**City of Charlottesville  
Board of Architectural Review  
Staff Report  
October 19, 2021**

**Prelim Discussion**

700 Locust Avenue, Tax Map Parcel 510066000  
Martha Jefferson HC District  
Owner/Applicant: Eric M & Galia Mann-Hielscher  
Project: Construct outbuilding

---

**3 Yard Elevation**  
SCALE: 1/4" = 1'-0"

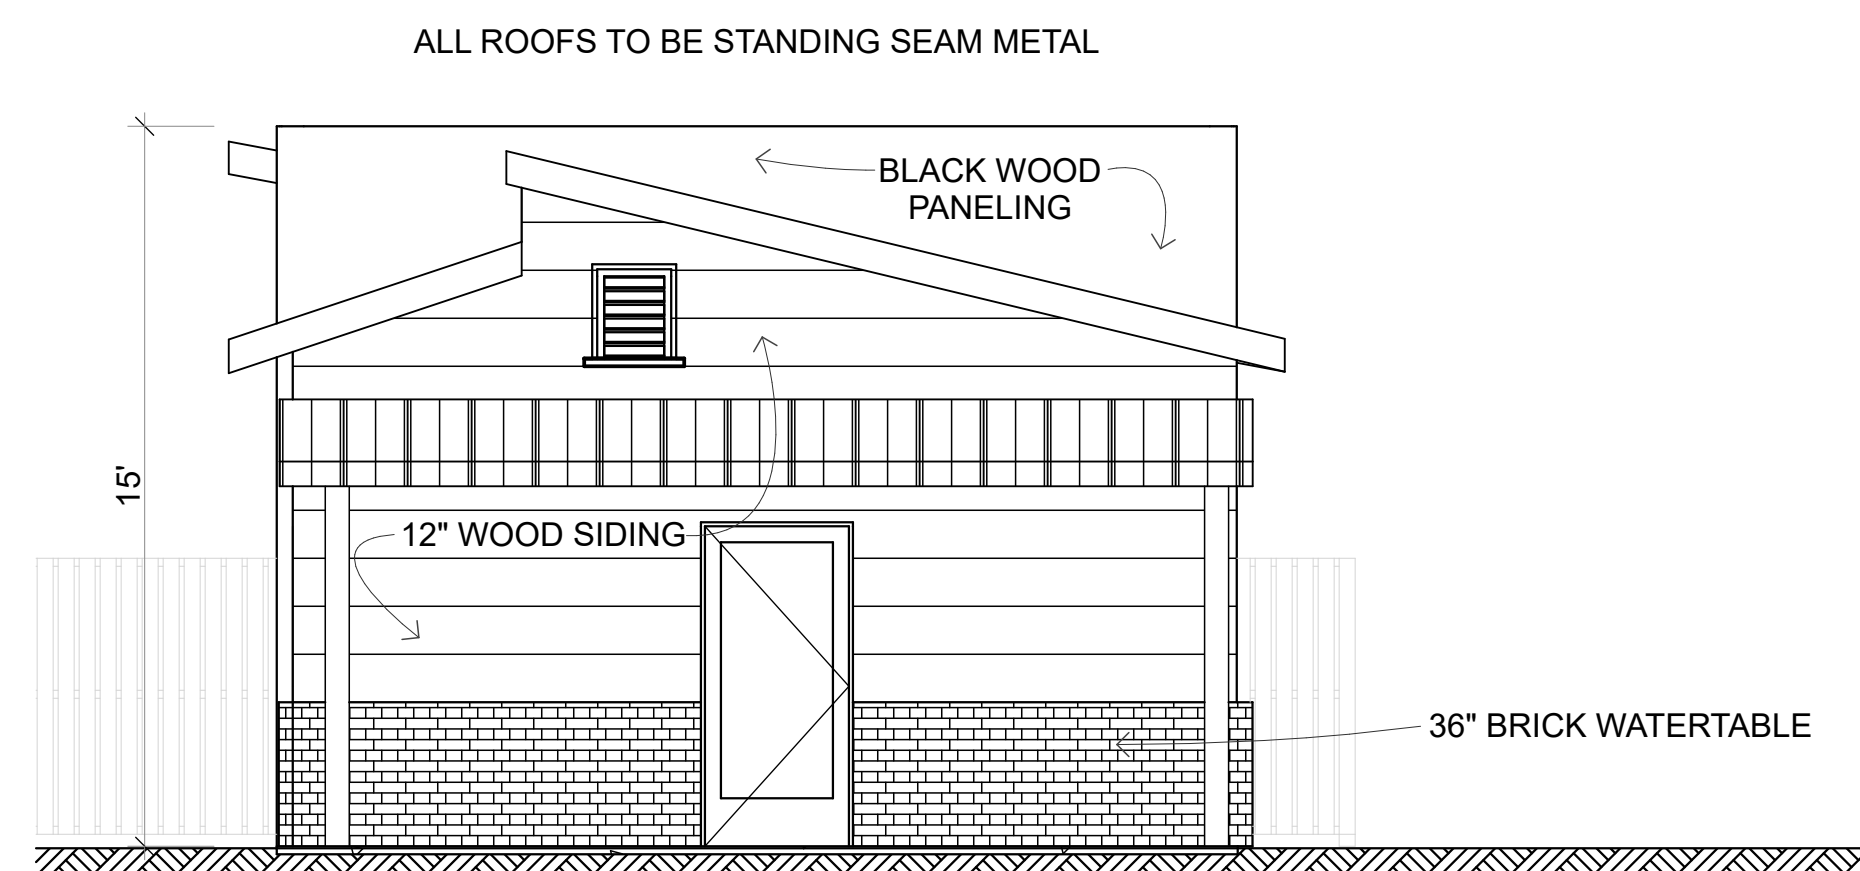
**Comment:** The windows and door on the Street, Alley, and Neighbor elevations follow a pattern and arrangement similar to other accessory structures. Those on the Yard elevation are somewhat unique.

**4 Alley Elevation**  
SCALE: 1/4" = 1'-0"

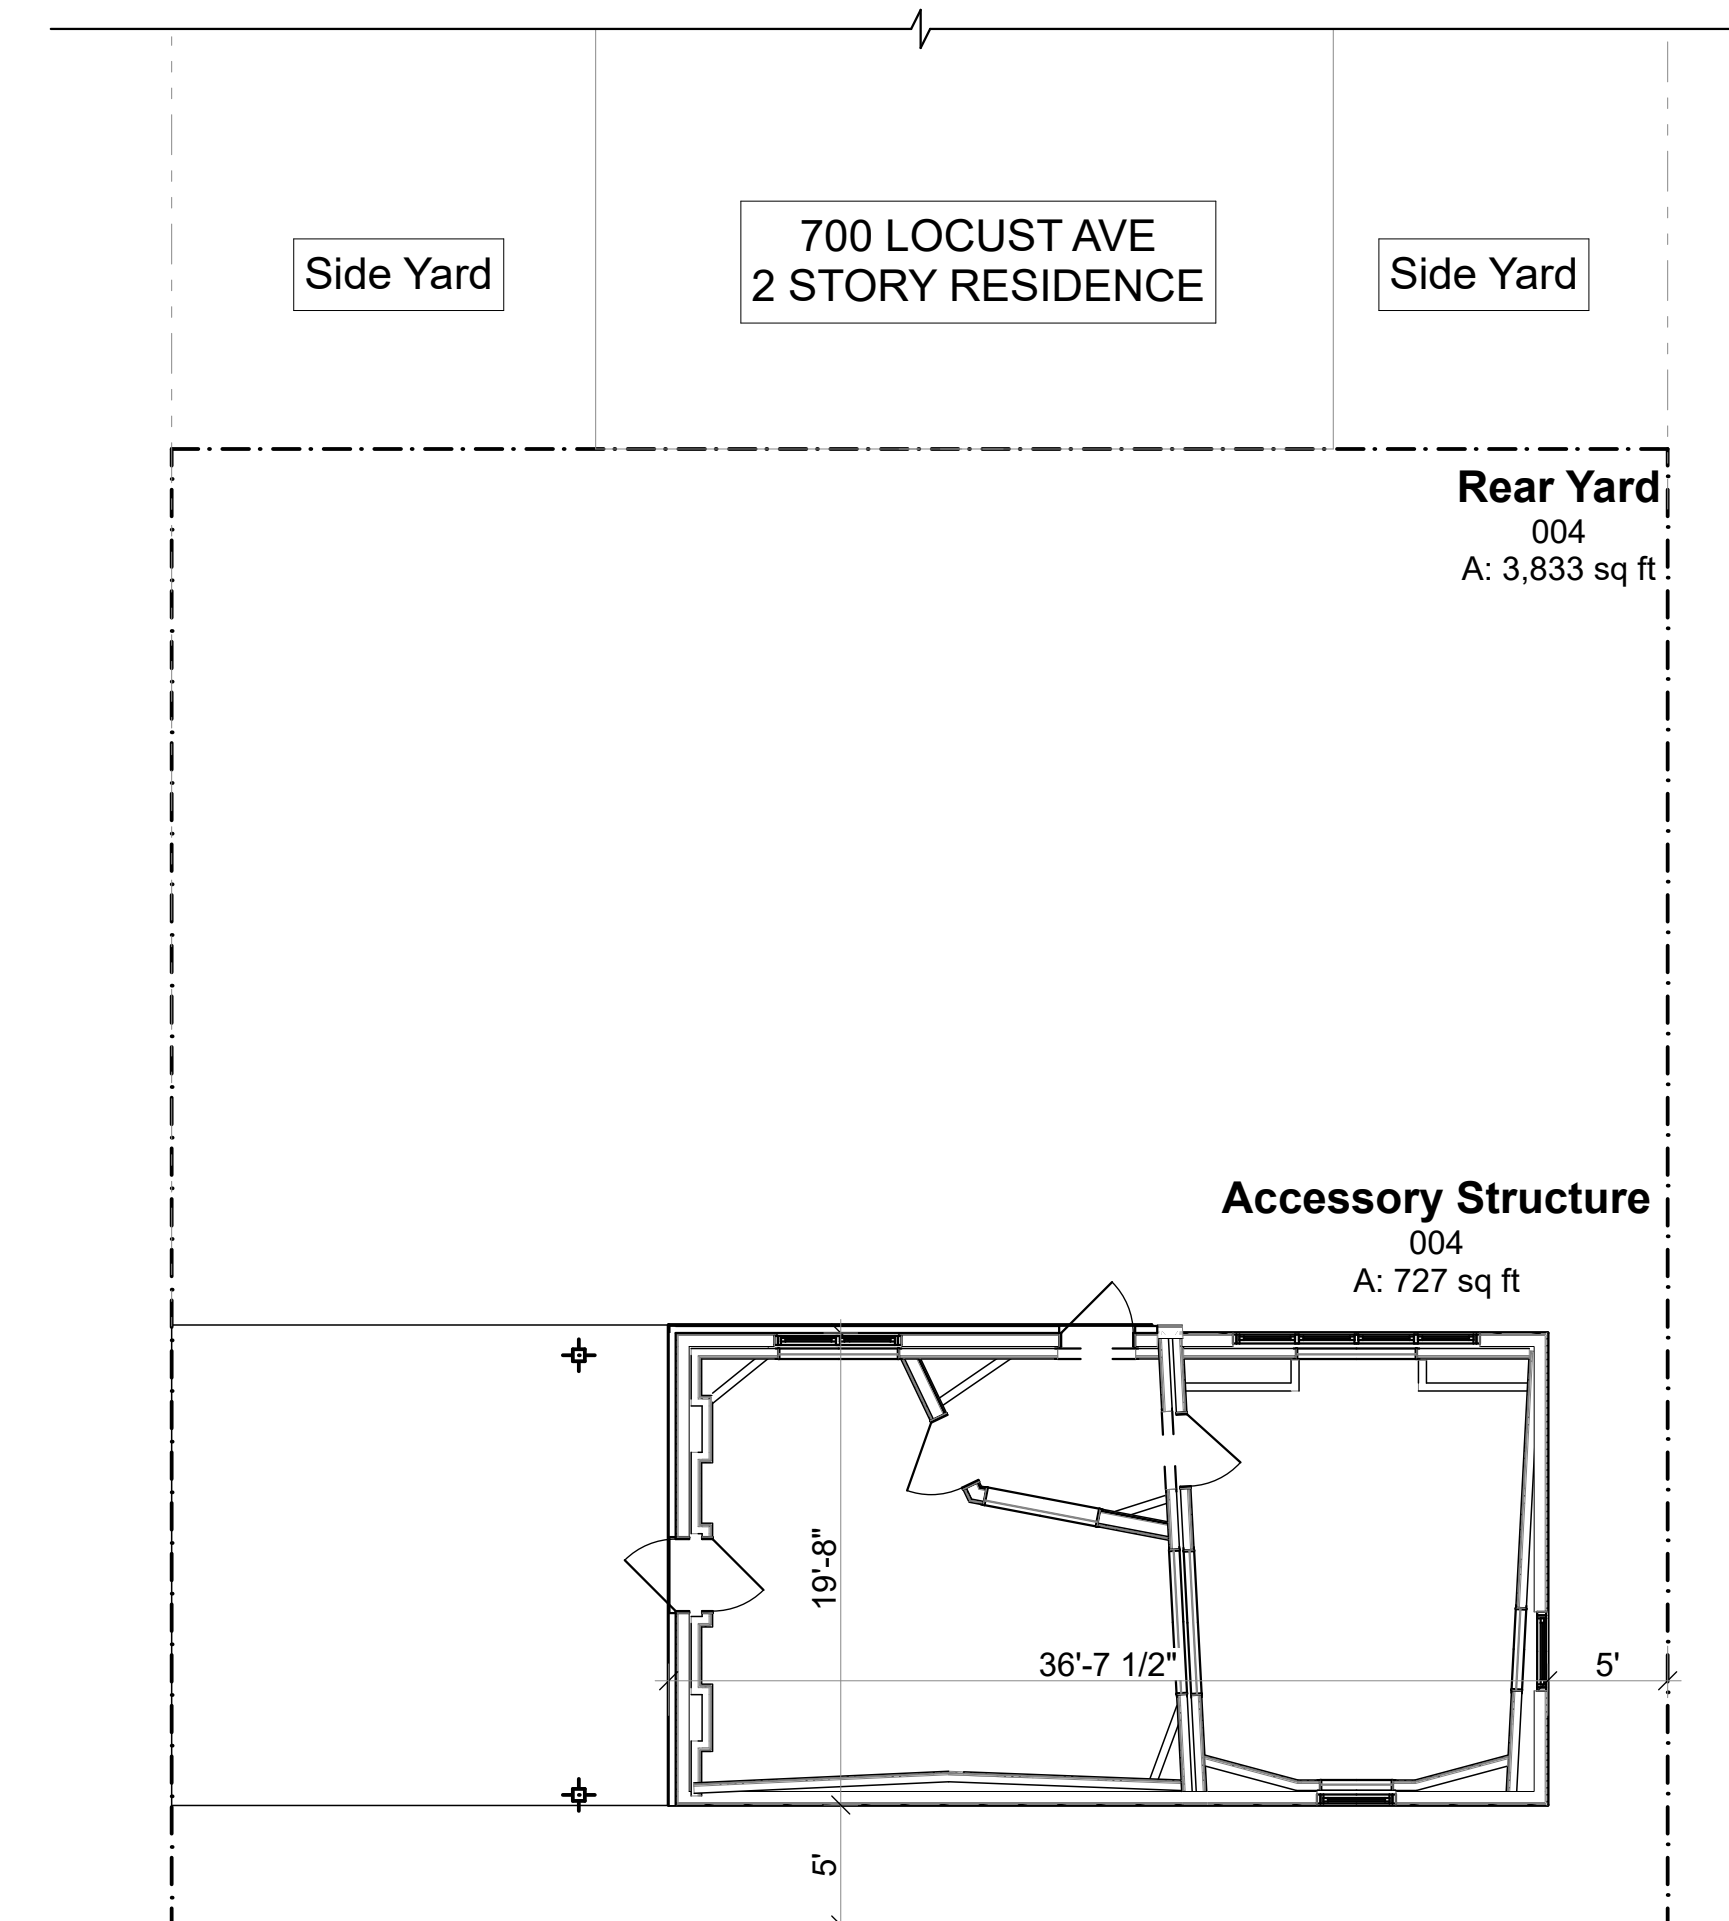
Staff comment to the applicant, October 12, 2021: The design reads a bit eclectic, so we'll see what the BAR thinks. Contemporary is fine, but they might question the mixed elements. The two segments need not be identical, but the elements of each should be consistent within that segment. For example, continue the bricks on the alley side of the long section or eliminate the bricks altogether. (See the two images below.)
